~~DRAFT~~
FINAL
DRAFT REPORT
TECHNICAL DOCUMENT REVIEW
CPS/MADISON INDUSTRIES
MIDDLESEX COUNTY, NEW JERSEY

EPA Work Assignment No.	: C02039
EPA Region	: II
Site No.	: 2P83
Contract No.	: 68-01-7331
CDM Federal Programs Corporation Document No.	: T1074-C02-DR-CNKR-1
Prepared By	: CDM Federal Programs Corporation
Work Assignment Project Manager	: John P. Mihalich
Telephone Number	: (212) 393-9634
Primary Contact	: Pat Evangelista
Telephone Number	: (212) 264-6311
Date Prepared	: November 1, 1988

Figure 3
Extent Of VOC Contamination In Groundwater

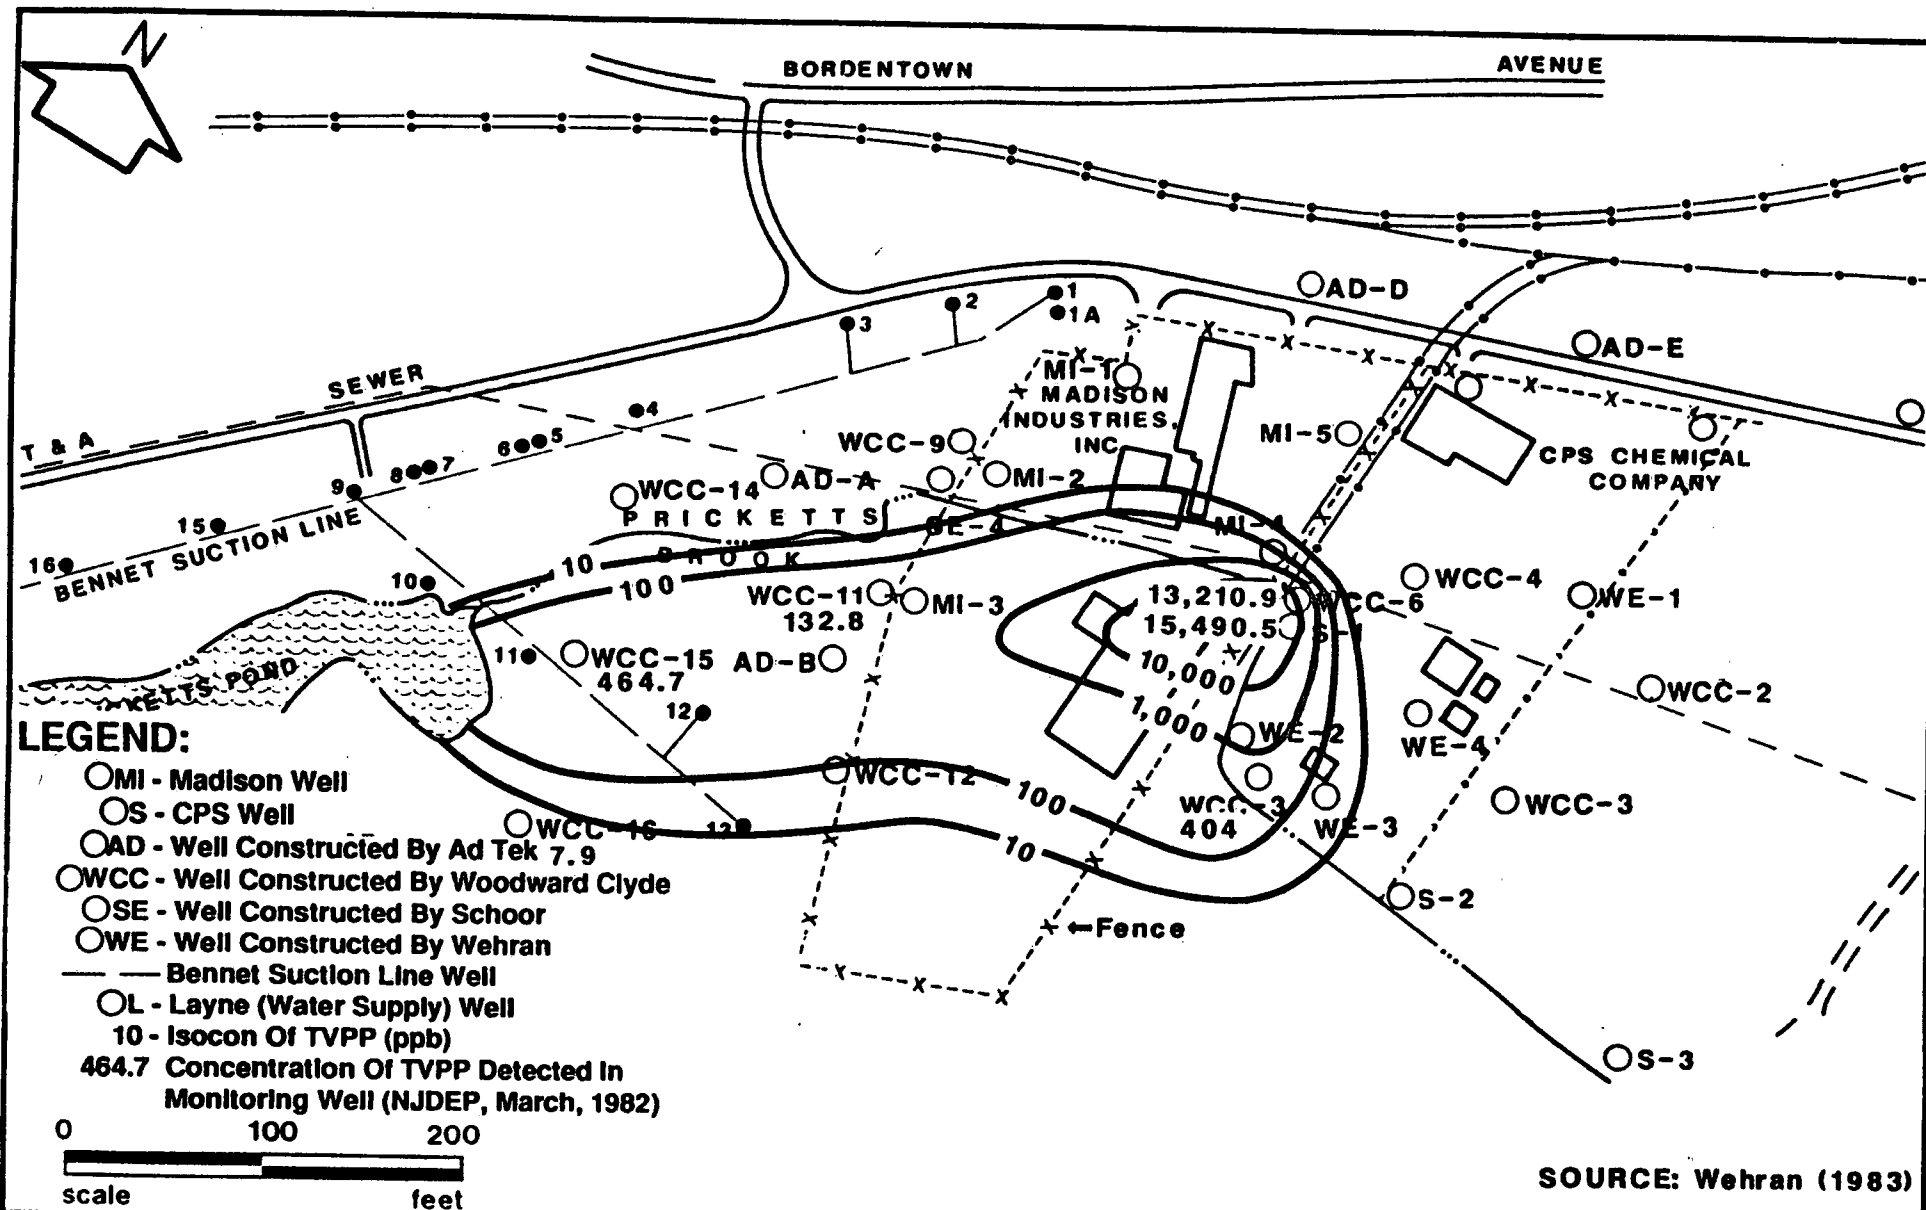
Comment. As pointed out by Geraghty & Miller (November 6, 1986), the current state of contamination (horizontal and vertical) must be determined before any remedial plan is implemented, due to the mobility of the contamination. The 1984 remedial plan by Wehran, for example, is based on data collected in 1982.

Figure 5
**Total Concentration Of Volatile Organics
 In The 0"-6" Interval**
 CPS/ Madison, Middlesex County, New Jersey

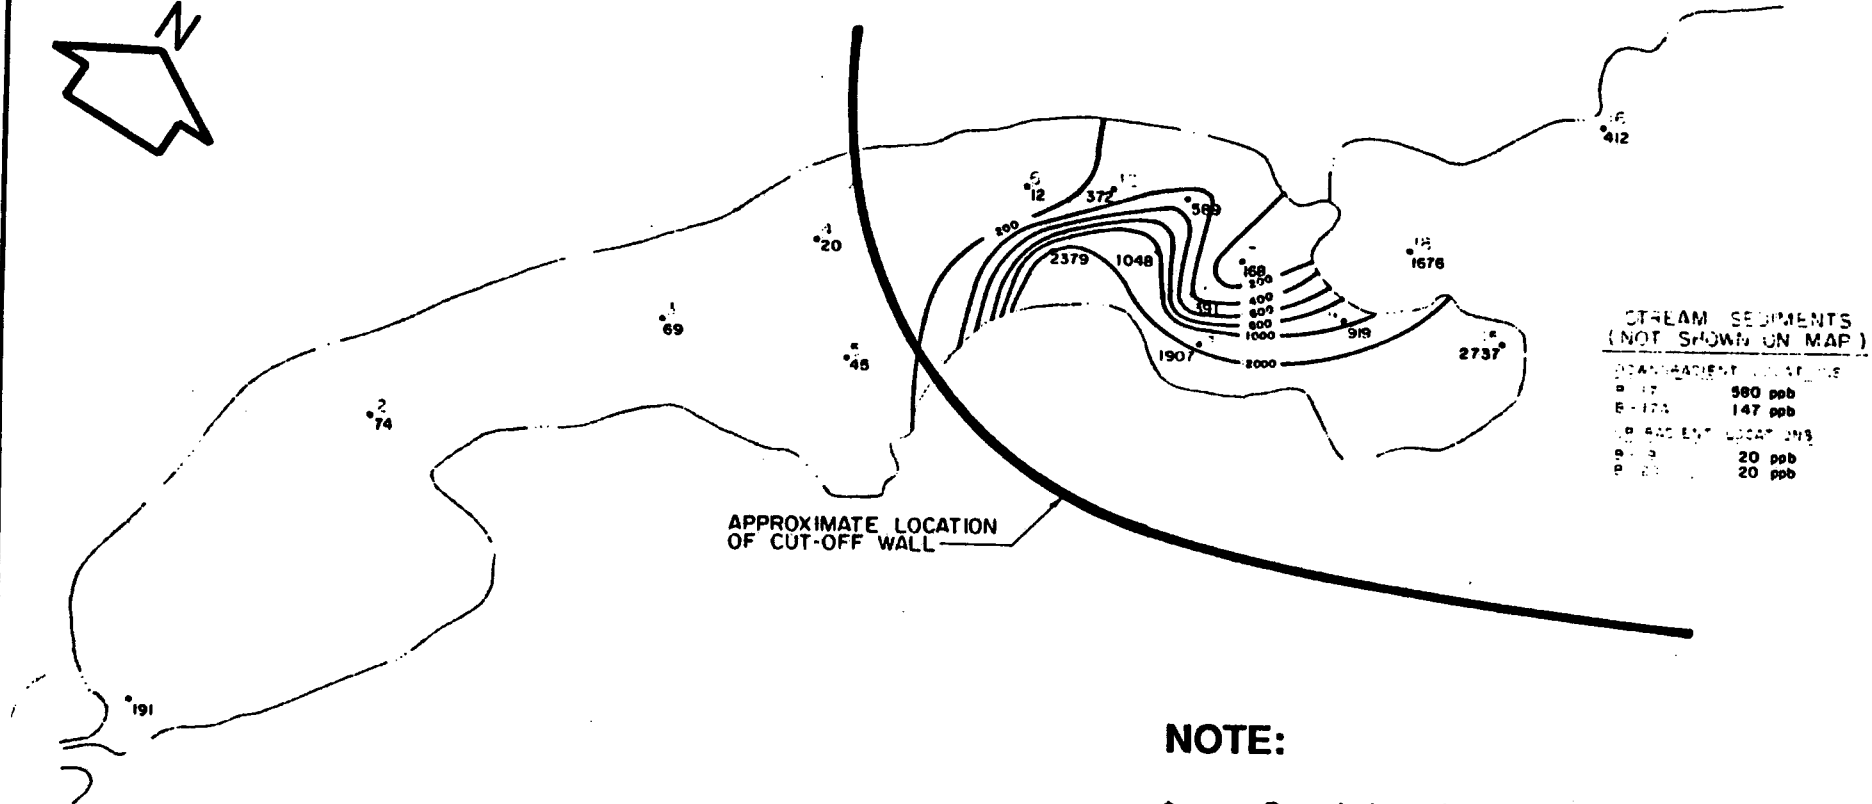
Comment. Wehran concluded that neither the concentration nor total mass of VOCs in the sediments warranted dredging, and that their proposed remedial plan would recover the contaminants. This idea concurs with SARA (Section 121), which discourages the off-site transport and disposal of hazardous substances without treatment.

Figure 6
 Location Of Slurry Wall, The "Bath Tub" Plan

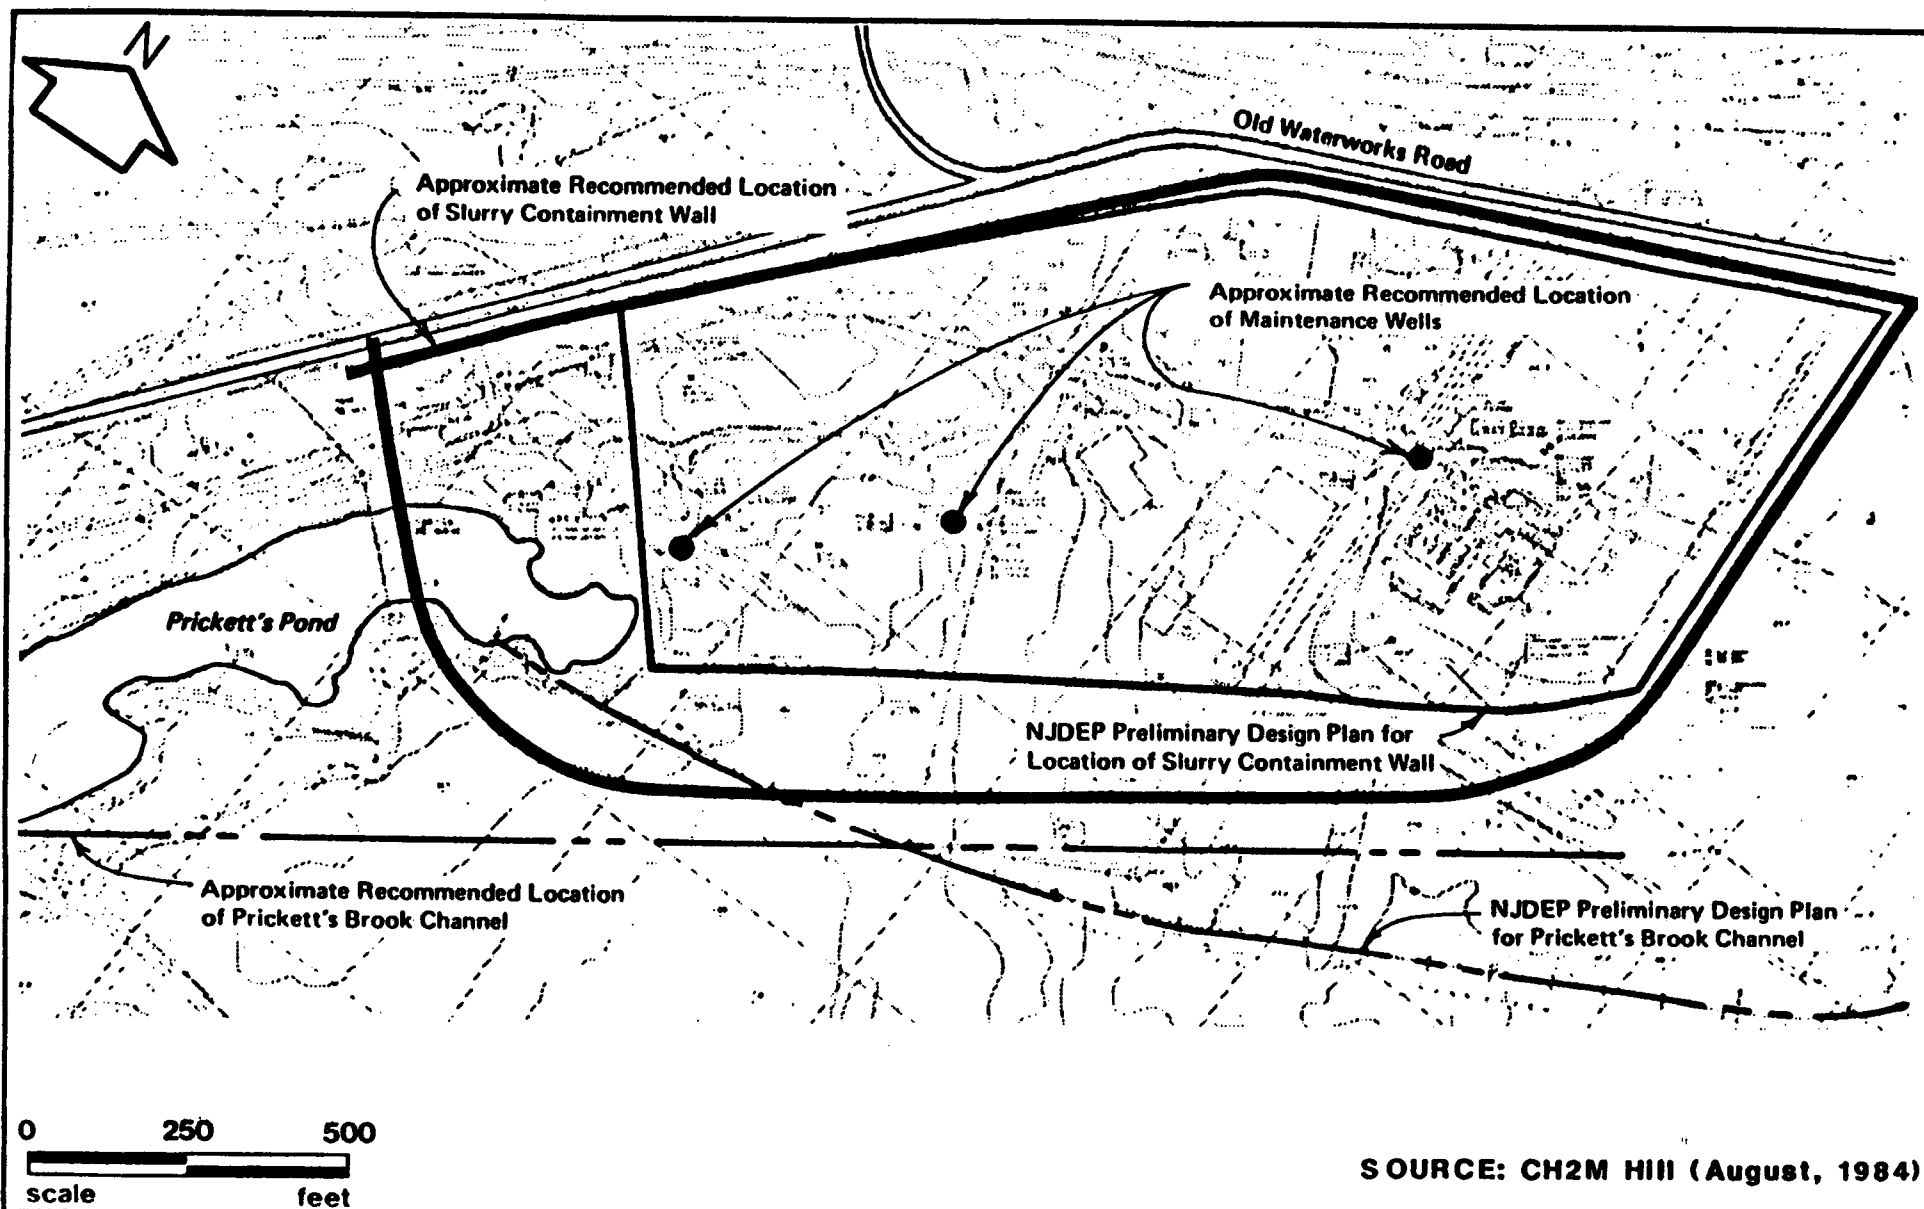
Comment. The plan suggested by CH2M Hill does not satisfy the following evaluation criteria of EPA guidance: effectiveness and overall protection of human health and environment, due to the lack of a continuous clay unit across the site.
